Strategic Infrastructure Development Section
An Coimisiún Pleanála
64 Marlborough Street
Dublin 1, D01 V902

Re: Case Ref. 324561 (PAX21.324561) – Crumhach Wind Farm, Co. Sligo – SSE Renewables (Ireland) Ltd.

Appendix A: Location of the turf bog

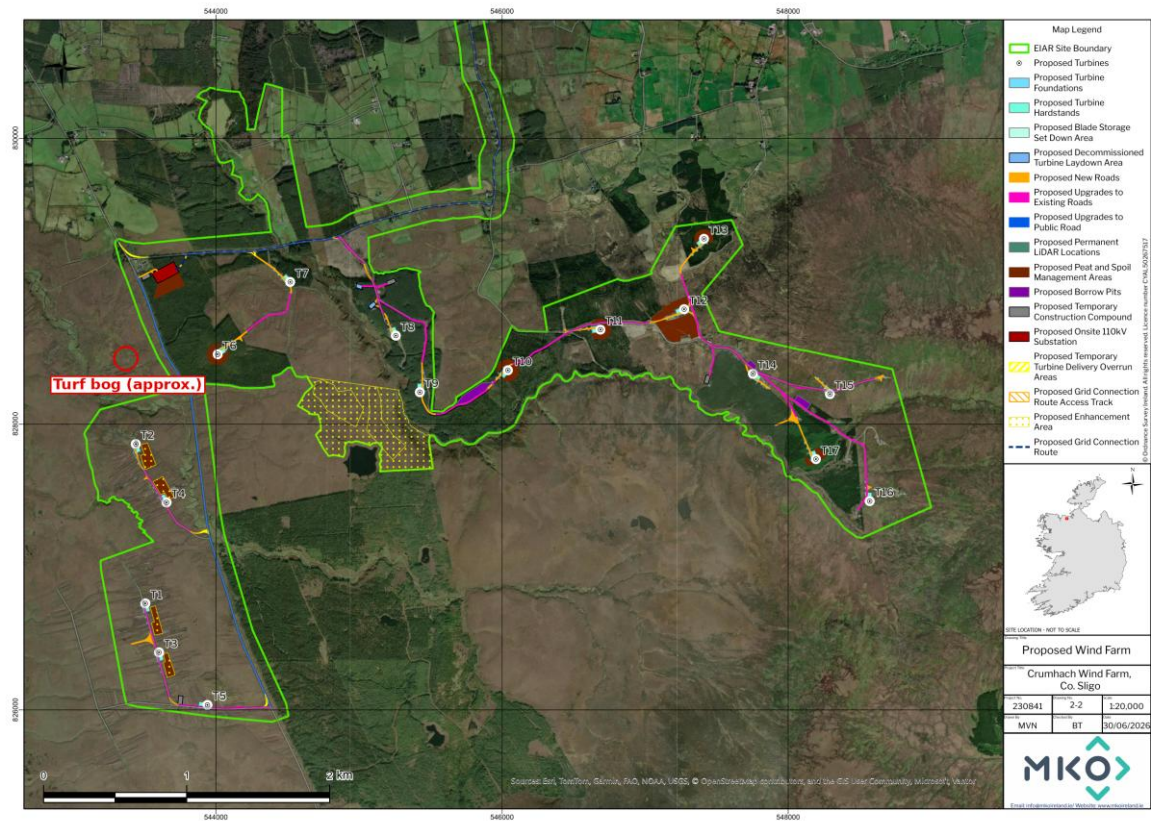
My family own / hold the turbary rights to a turf bank at Crowagh, Co. Sligo (GPS 54.201909, - 8.867948; ITM E 543370, N 828458), which my family and I have cut and saved for over 50 years. The bog lies immediately west of the wind farm site boundary, beside the public road that the application proposes to upgrade. Measured from the turbine coordinates in Table 4-1 of the EIAR, it is about 600 metres from proposed turbine T2 and about 640 metres from T6, with T4 about 1.0km and T7 about 1.3km away. Its position is marked on the applicant's own layout drawing at Appendix A. Chapter 5 of the EIAR (Section 5.3.7) records turf cutting as an established land use in the area, but the application does not identify individual turbary users, and I have not been contacted by the applicant about my bog. I ask the Commission to take account of the following.

- 1.2 If the road is closed, blocked by works or congested with HGVs during a dry spell, the turf cannot be saved or brought home, and a full year's fuel for my household can be lost. Drawing home turf means slow-moving tractors and loaded trailers sharing a narrow road with construction HGVs. The road upgrade could also remove or damage the entrance to the bog, or leave a new road edge, verge or drain between the road and the bank that tractors cannot cross.

- 1.3 I ask that access to my bog be maintained at all times throughout construction; that no road closure or major works take place on the access road during the main turf-cutting and drawing-home season without my agreement; that I receive at least four weeks'

written notice of any works on the access road; that the entrance to the bog be retained and, where works affect it, reinstated to a standard suitable for tractors and loaded trailers; and that the applicant be required to identify and consult all turbary rights holders before the Construction and Traffic Management Plans are finalised.
